Ottawa, December 5, 2021  
No.: 1186-Shillington-YME-L2

**Subject:** Detailed description, geotechnical recommendations and conclusions based on the findings in the referenced testholes shown in figure 1B in page 1 in response to the following city comments:

“Geotechnical Memo, 1186-Shillington-YME-L1, prepared by Yuri Mendez Engineering, dated November 20, 2018.

Figure 1: Test-hole Location (A) and test-hole logs (B)

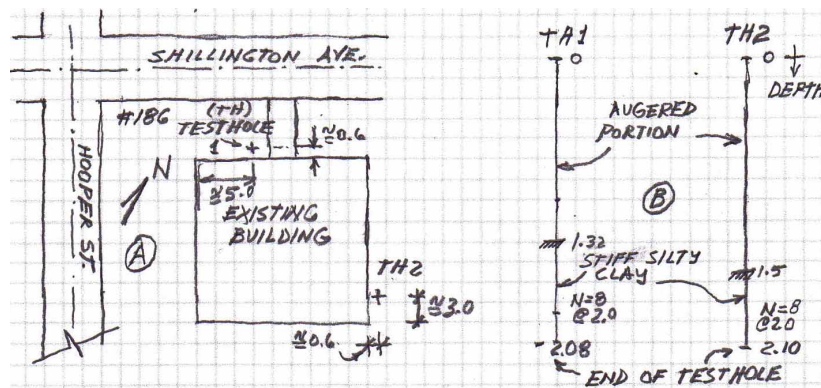
1. Provide a detailed site description.
2. Provide geotechnical recommendations and conclusions for the suitability of the site for the proposed development. “

The site is developed land consisting on the 1186 Shillington Ave. parcel in a city block within the City of Ottawa. It is relatively flat and is partially covered by a 2 storey residential building, landscaped areas and parking.

The data base by Belanger (1998) suggests 5 to 10 m of overburden soils at this site.

The site is suitable for the proposed development based on the support capacity provided under letter 1186-Shillington-YME-L1 issued on November 20, 2018 for this site.
